UNITED STATES PATENT AND TRADEMARK OFFICE

APPLICATION NO.	FILING DATE	FIRST NAMED INVENTOR	ATTORNEY DOCKET NO.	CONFIRMATION NO.
10/803,474	03/17/2004	Stan Cheng		5465

Office Action Summary	Application No. 10/803,474	Applicant(s) CHENG, STAN	
	Examiner Philip Gabler	Art Unit 3637

DETAILED ACTION

Exhibit 1: Jeong '624 Figures 1 and 4C

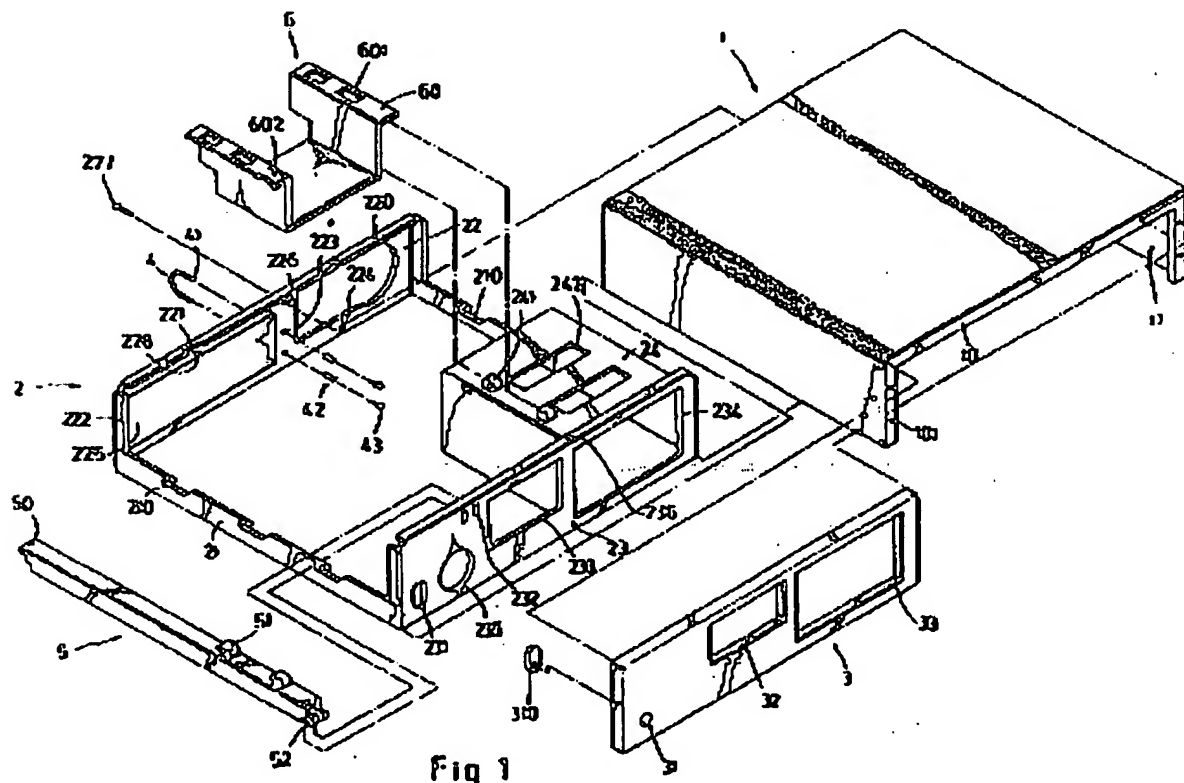
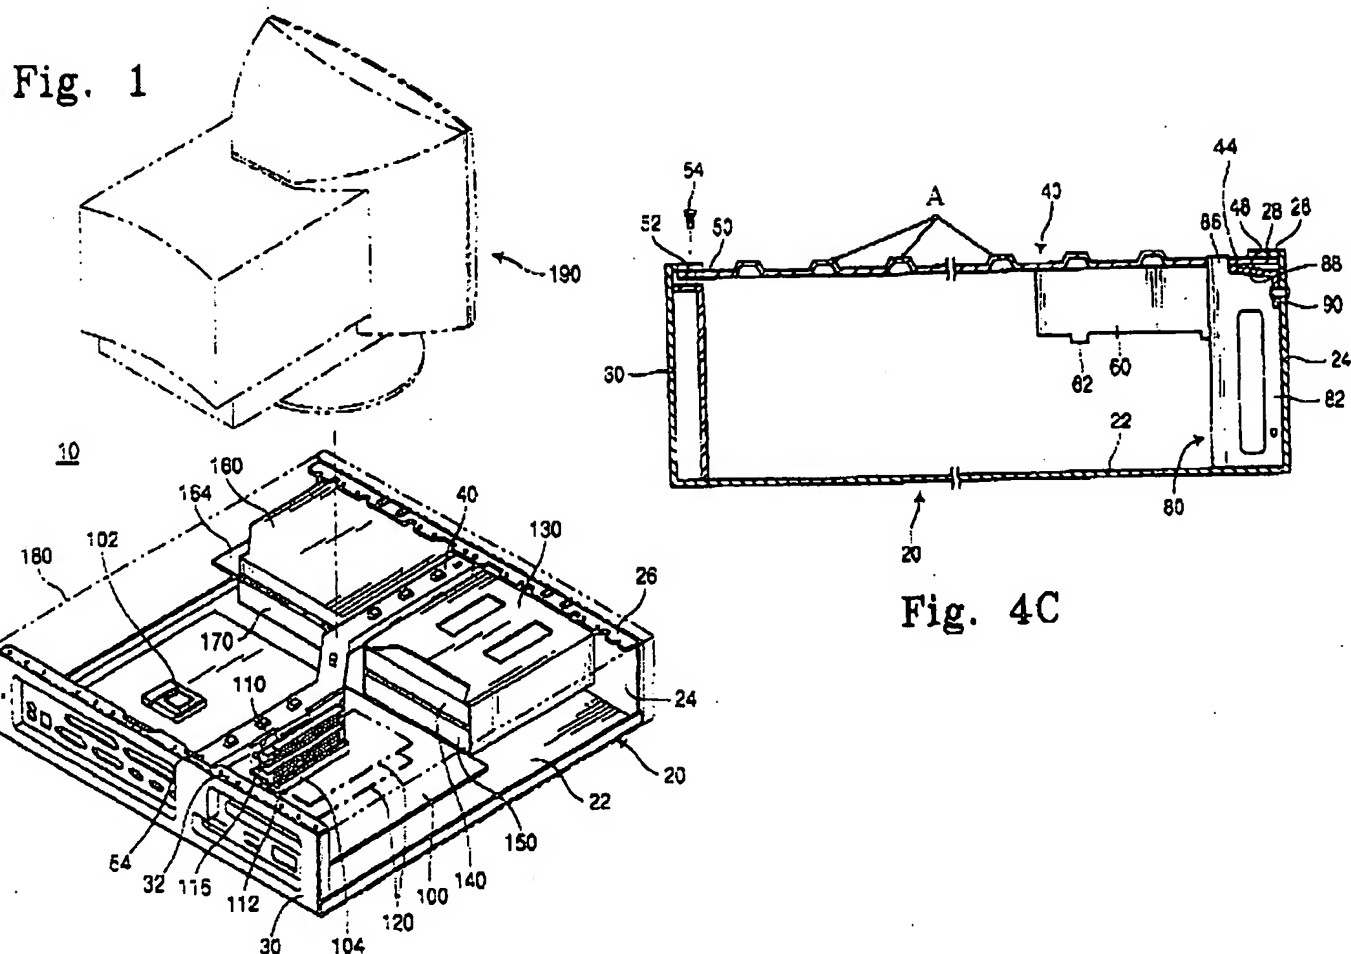
3. Regarding claims 1, 2, 9, and 13, Chang (Figure 1) discloses a chassis apparatus usable with a computer comprising: a chassis frame (2, including 5, 24, etc.) comprising a set of load-bearing rails (5, portions of 24) located on edges of the frame; and a plurality of protrusions (51, 241) formed on tops of the load-bearing rails, and to laterally secure a removable structure (6) to the chassis frame by coupling the protrusions with portions (60) of the structure formed to be secured thereover, the removable structure configured to be capable of housing at least one small form factor computer component (element 6 is a drive holder). Chang does not disclose the protrusions as supporting a chassis cover (which is present as element 1). Jeong (Figures 1 and 4C) discloses a computer chassis apparatus including a load-bearing surface (upper surface of 40) including protrusions, or means for supporting a chassis cover, (viewed as A in Exhibit 1) configured to support a chassis cover (180). [See

Figure 4C and column 4 lines 2-7 for disclosure of 40 (and protrusions A) acting as a support for the cover, monitor, etc.] Accordingly, it would have been obvious to one of ordinary skill in the art to replace Chang's protrusions with Jeong's protrusions (i.e. domes which would engage the cover in place of hooks that do not) because this arrangement would provide additional strength and support to the chassis apparatus by better supporting the cover while still securing the removable structure (the holes of the removable structure would be fitted over and around the protrusions, laterally securing the structure in at least two directions).

corresponding to each rounded structure. Chang does not disclose domes on the upward facing surfaces for supporting a chassis cover (the cover present as element 1). Jeong discloses a computer chassis frame with domes (A) formed on an upward facing surface for supporting a chassis cover. Accordingly, it would have been obvious to one of ordinary skill in the art at the time the invention was made to modify Chang's oblong rounded structures to be domes as taught by Jeong because this arrangement would make installation and removal of the removable drive frame quicker and more simple (the frame could simply be placed on the upward facing surfaces with the interface structures fitting over the domes rather than sliding under hooks) as well as providing better support for the cover.

meeting the limitations set forth in the claims. Specifically, the combination of Chang and Jeong discloses protrusions or oblong domes as claimed, the rails being viewed as located (at least broadly) at edges of the frame. Accordingly, the 35 USC 103 rejections have been maintained.
